CORRIGENDUM

Organigramme 2C - Origine du feu

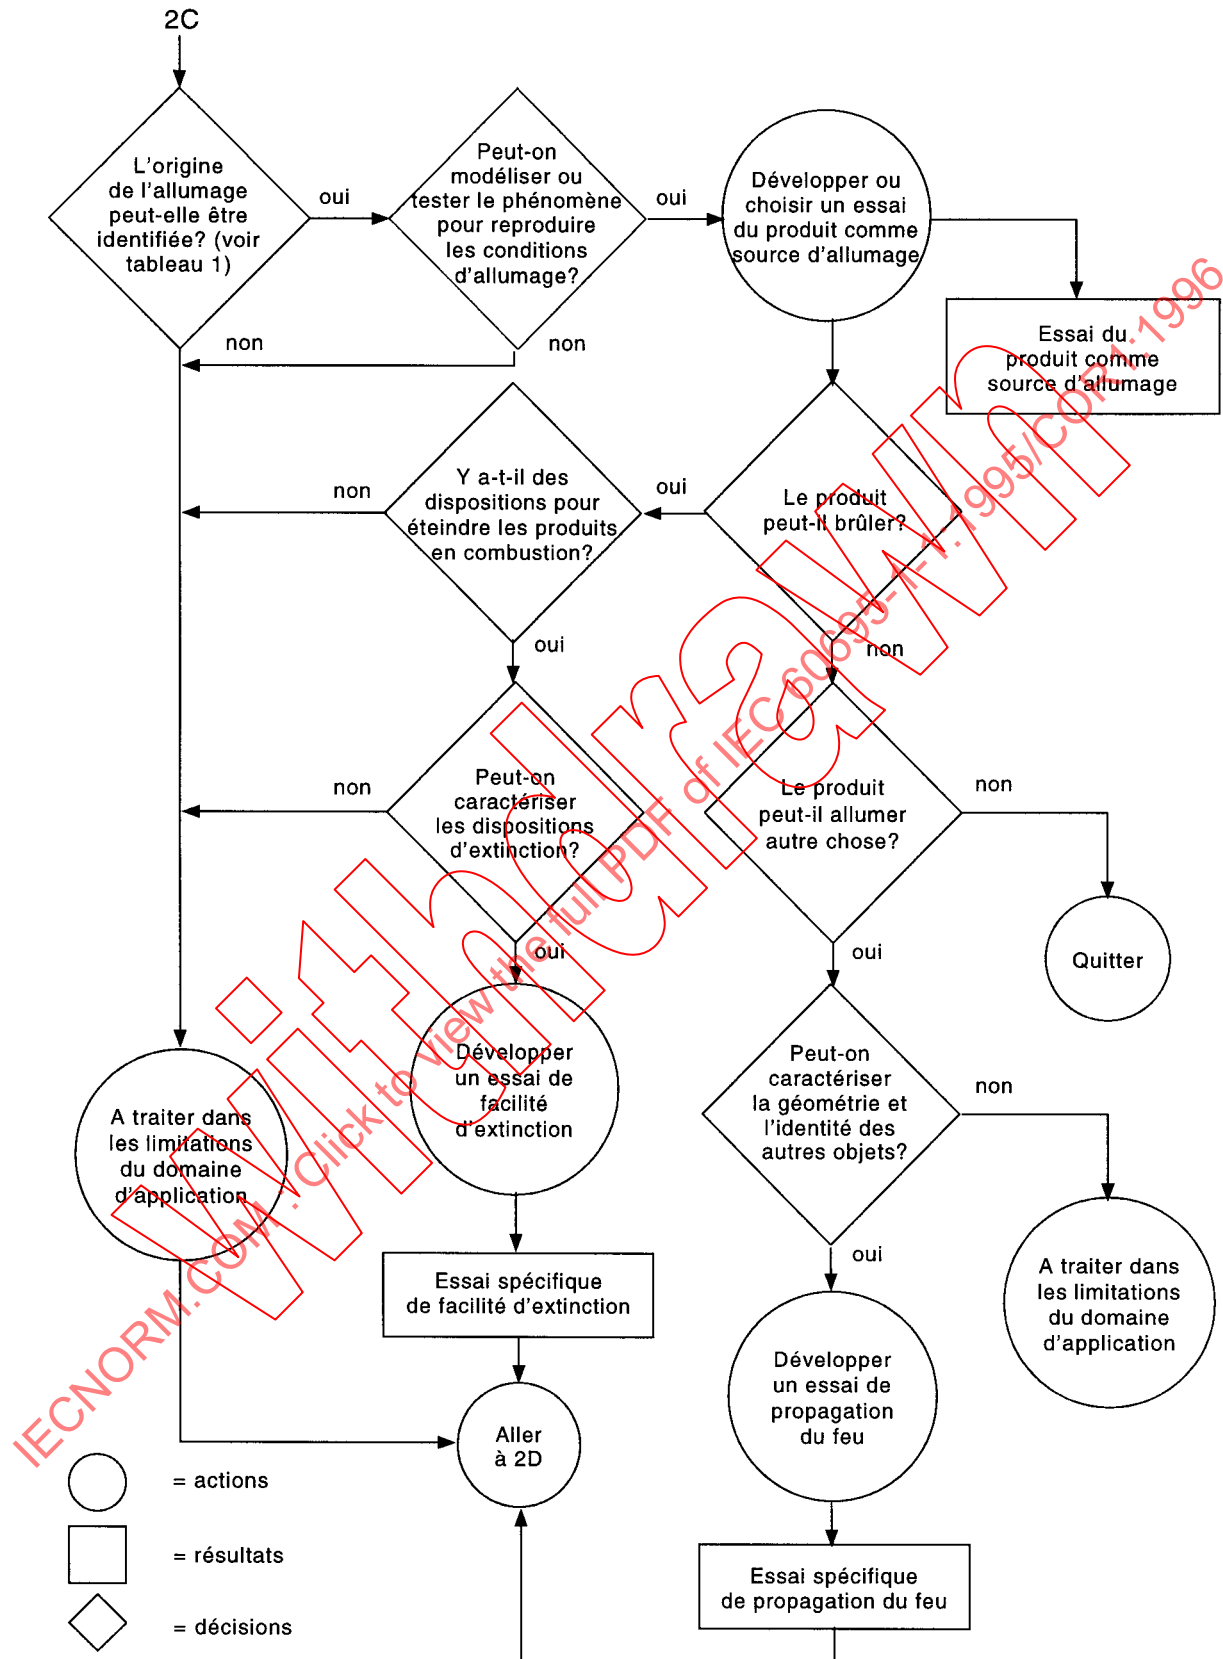
Organigramme 2C

La flèche à gauche du carré de décision Le produit peut-il brûler? doit être inversée, c'est-à-dire que la flèche doit pointer vers le carré de décision: Y a-t-il des dispositions pour éteindre les produits en combustion?

Flow chart 2C - Origin of fire

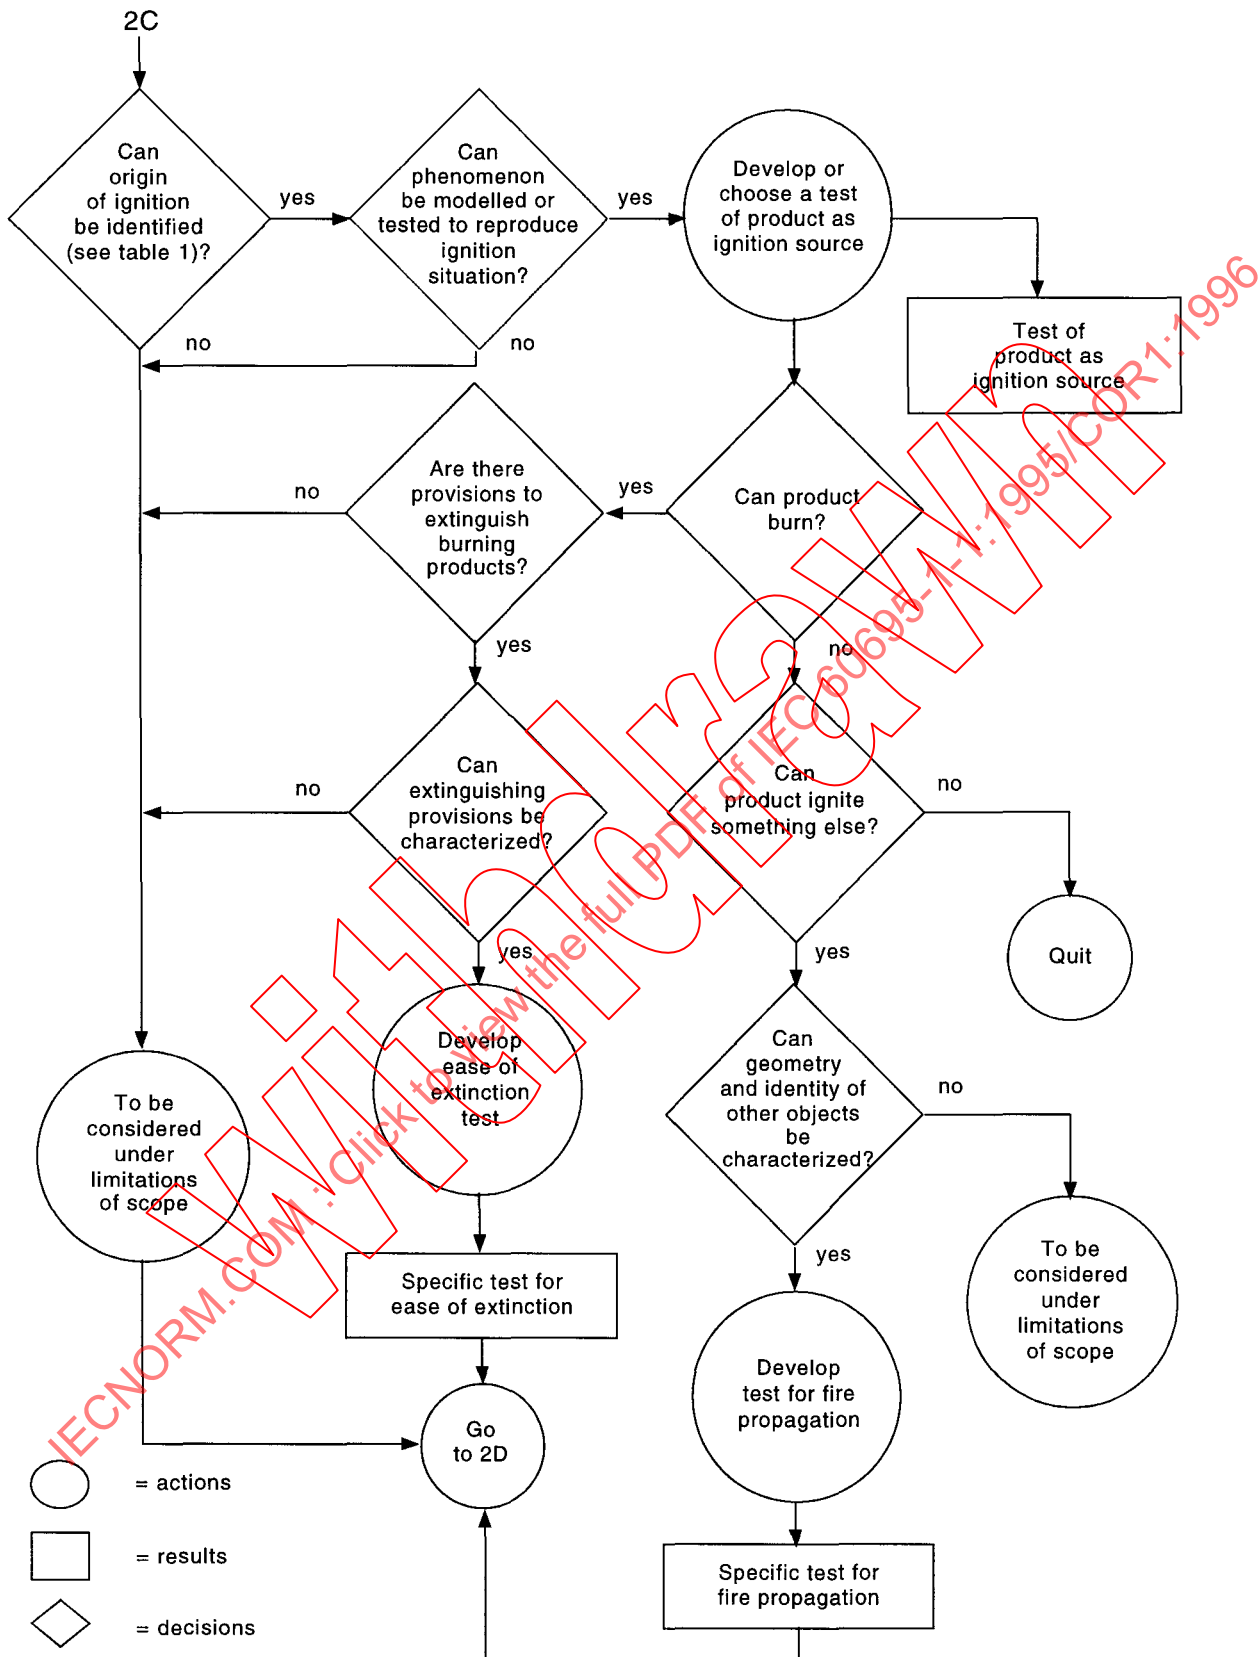
Flow chart 2C

The arrow to the left of the Can product burn? decision box should be reversed; i.e., the arrow should point towards the Are there provisions to extinguish burning products? decision box.

Organigramme 2E - Autres objets non électrotechniques combustibles (facultatif)

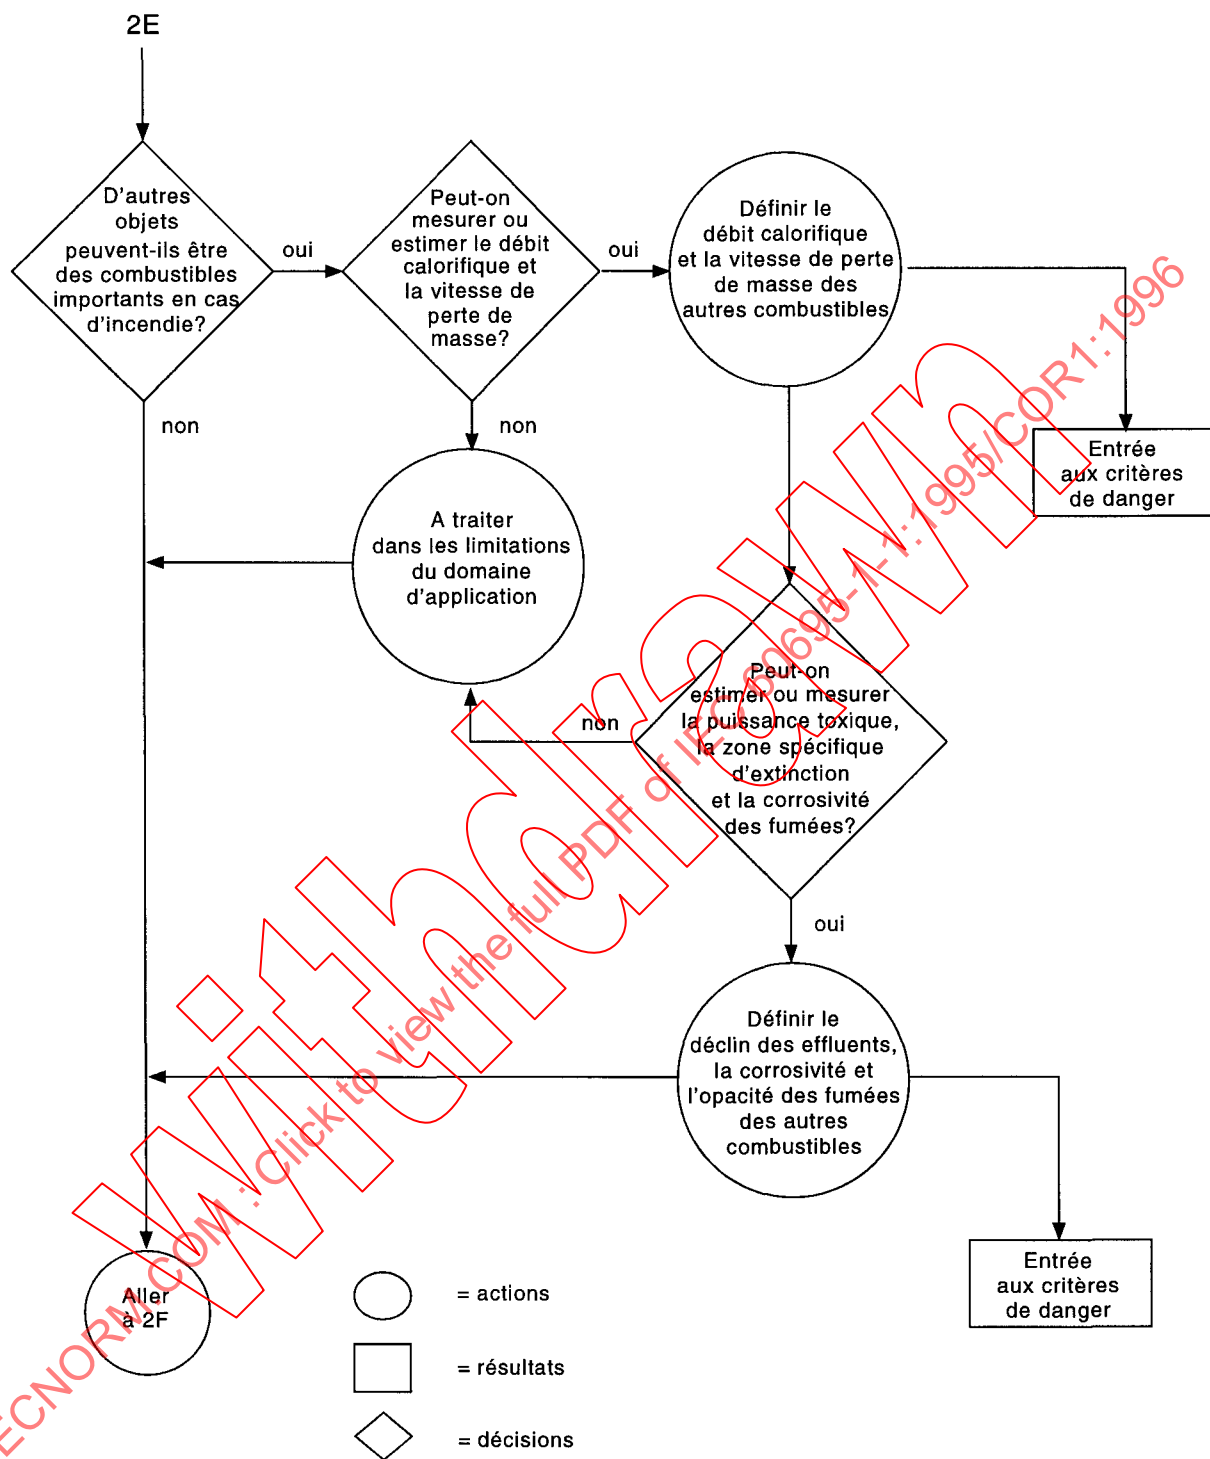
Organigramme 2E

a) La ligne sous le cercle d'action Définir le débit calorifique et la vitesse de perte de masse des autres combustibles doit être une flèche pointée vers le bas, vers le carré de décision qui indique: Peut-on estimer ou mesurer la puissance toxique, la zone spécifique d'extinction et la corrosivité des fumées?

b) Dans le cercle d'action de l'angle inférieur gauche, au lieu de Aller à 2E lire Aller à 2F

Flow chart 2E

a) The line below the action circle Define heat release rate and mass loss rate of other fuels should be an arrow pointing towards the decision box entitled: Can toxic potency, specific extinction area and corrosivity of smoke be estimated or measured?

b) In the action circle in the bottom left corner, instead of Go to 2E read: Go to 2F
